Tropical Knitex Ltd.

Chandra, Kaliakoir, Gazipur-1751, Bangladesh

24th September 2019 , 6th October 2019 & 15th October 2019

Observations

Lateral Stability of Steel Stair

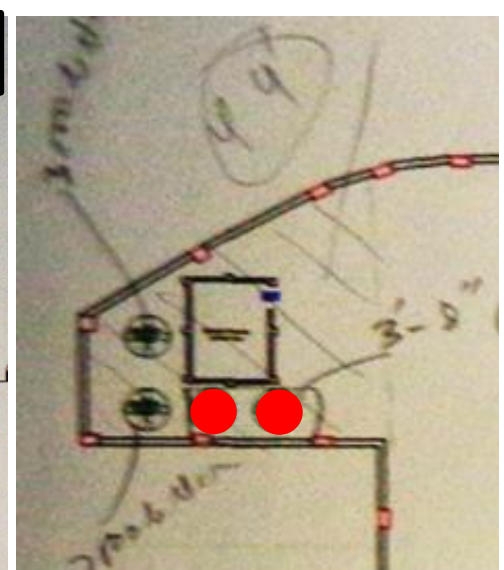
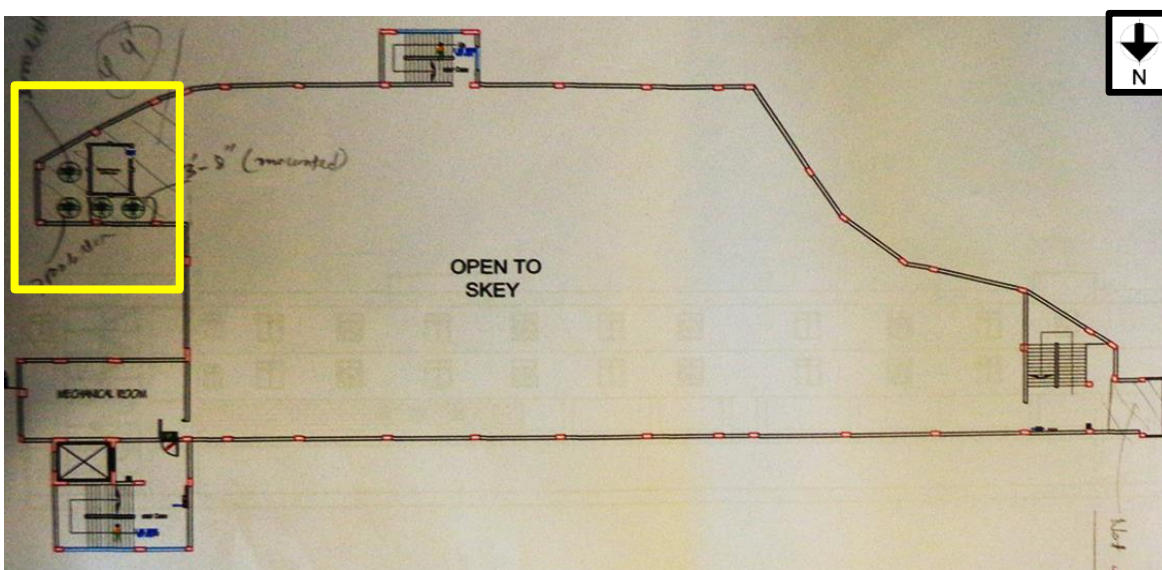
No obvious lateral load resisting system of the steel stair was found. Factory engineer is required to check the stability of the steel stair against lateral loading.

Roof floor Layout plan. Location of plastic water tank

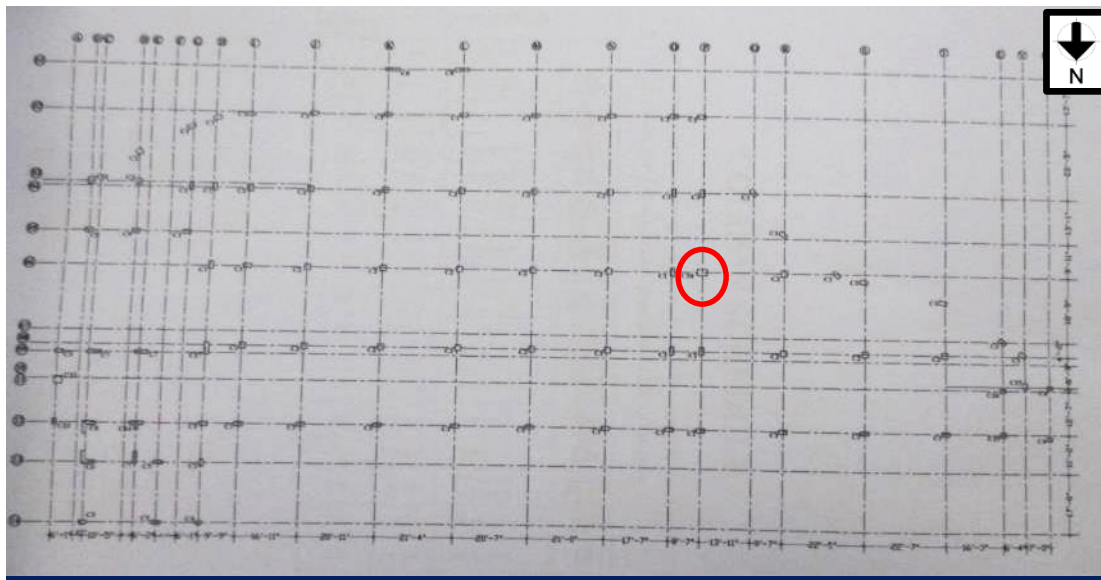
At roof, 1.12 m pedestal was found supporting plastic water tank. No information regarding the pedestal has been provided in as-built drawing. Factory engineer is required to assess the capacity of the slab, carrying the load of plastic water tank & pedestal.

Column Layout plan.

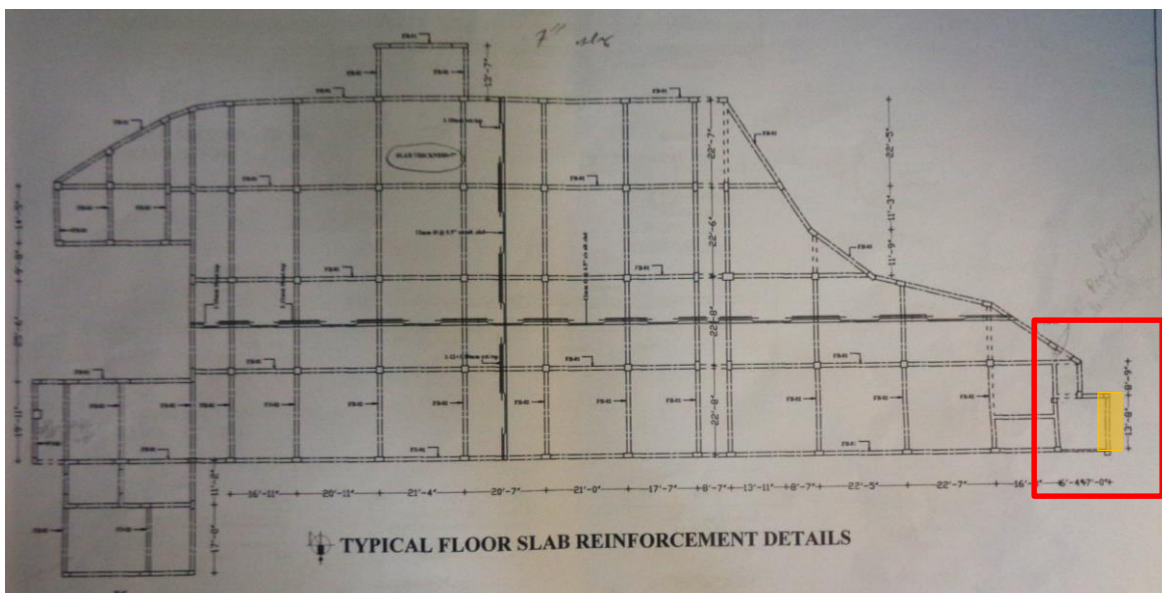
Size of C10 at grid P/6 column has been shown 825mm X 550mm. But at actual site condition the column size was found 500mmX500mm. Factory engineer is required to survey the structure and update the column schedule with re-bar details.

Cantilever slab

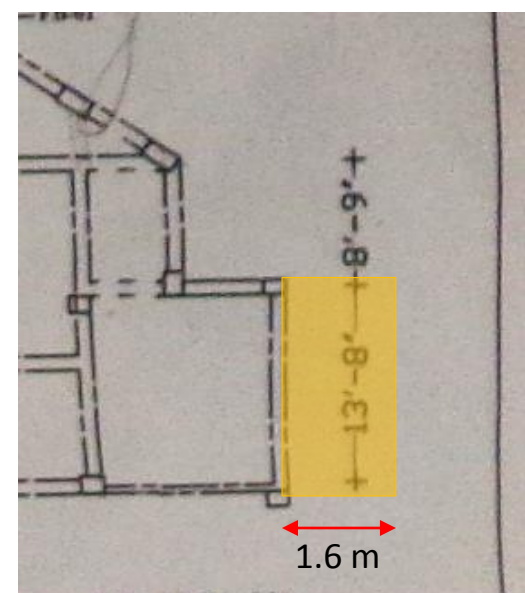
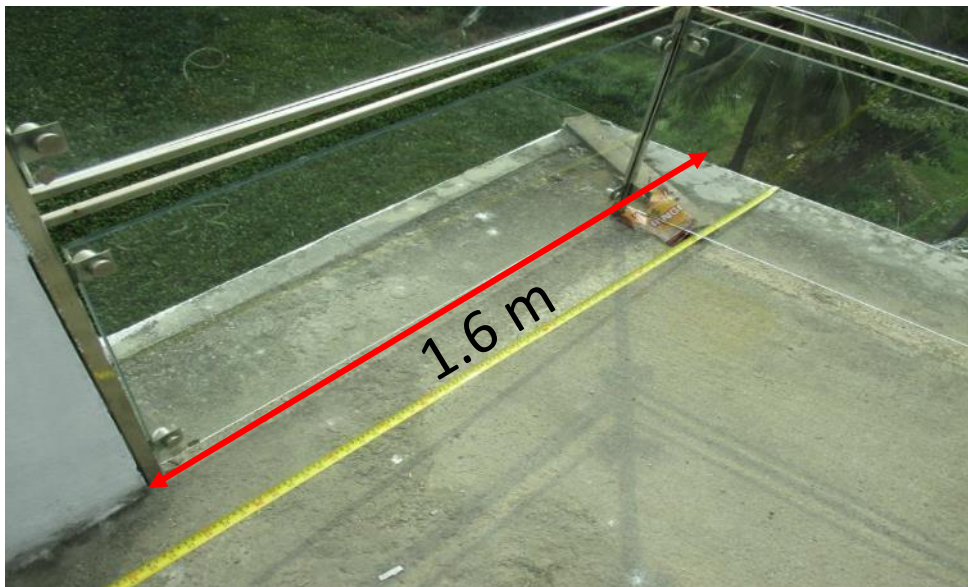
1.6 m cantilever slab was found at west side of the building. The slab details has not been added in as-built structural drawing. Factory engineer is required to develop accurate as-built drawing and assess the load bearing capacity of the cantilever slab.

Electrical outlet hole in column

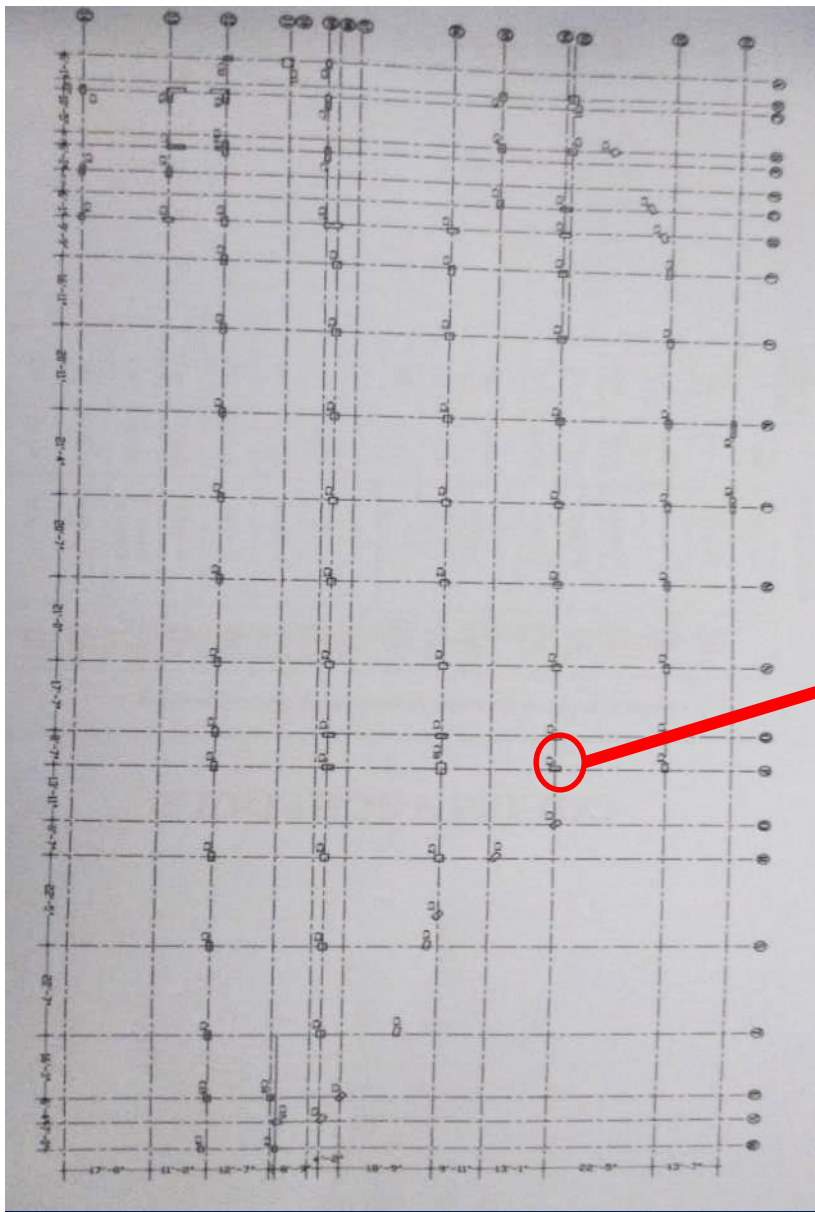
Hole was found in column due to electricity outlet purpose at marked column in figure. Factory engineer is required to investigate the hole and suggest repair methodology.

Hairline Crack in beam

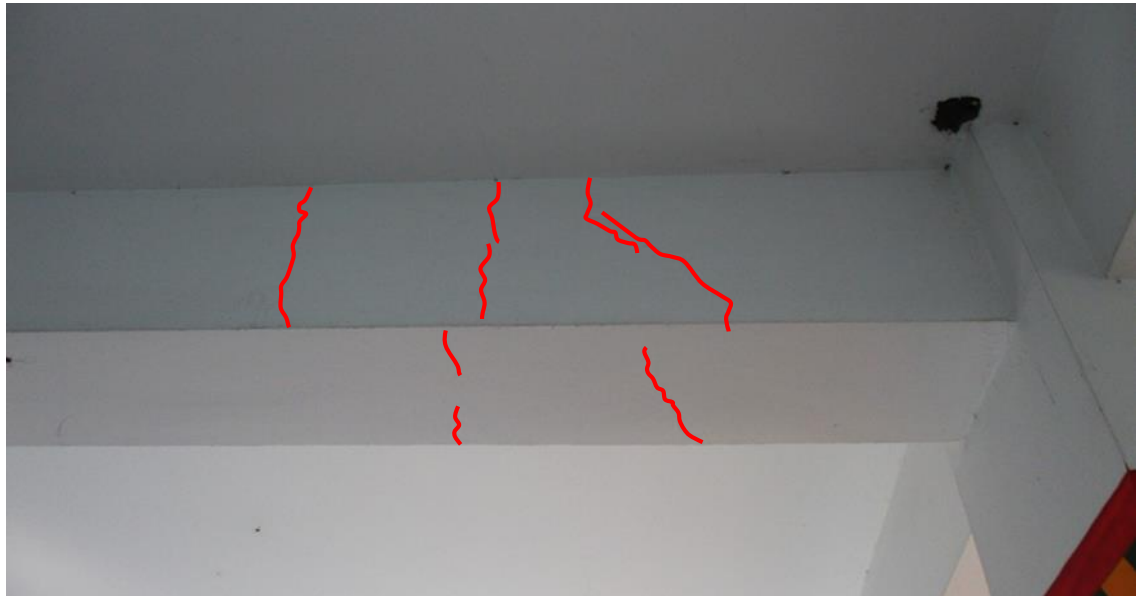
Hairline crack was found in beam at several locations of the structure. Factory engineer is required to investigate the cracks and produce a crack investigation report including the reason, extend of crack and recommendation for the repair of the cracks.

Typical section drawing

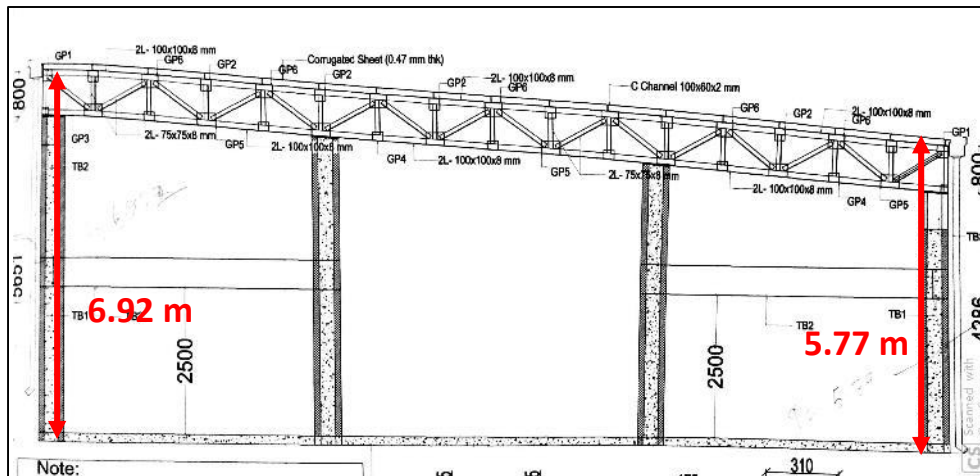
Number of vertical members in the truss were found less than the number shown in as built drawings. In as built drawings, 14 vertical members are shown but on site 12 were found.

Also on site the heights from floor to truss top were found greater than the height value mentioned in the as built drawings.
